Roof Replacement
At DeIDOT West Wing Building
800 Bay Road
Dover, Delaware

ADDENDUM #1
June 8, 2016

OMB/DFM Contract No. MC5511000012

12a
A102

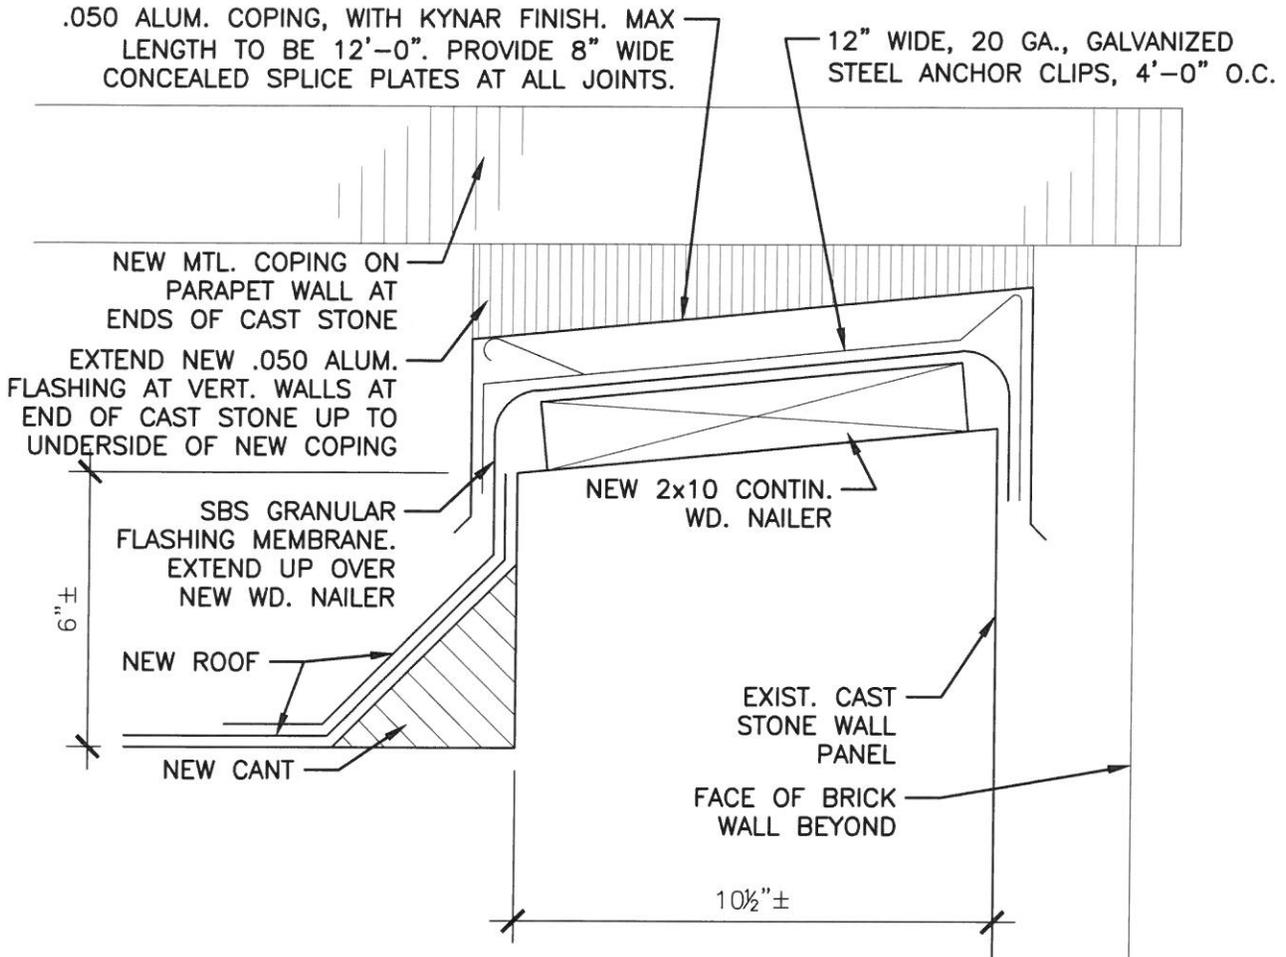
Delete cast stone parapet at R10, new cap flashing detail 12A/A102.

Insert revised detail 12A/A102 shown on Addendum No. 1 Sketch 12A/A102 Revised 6/8/2016.
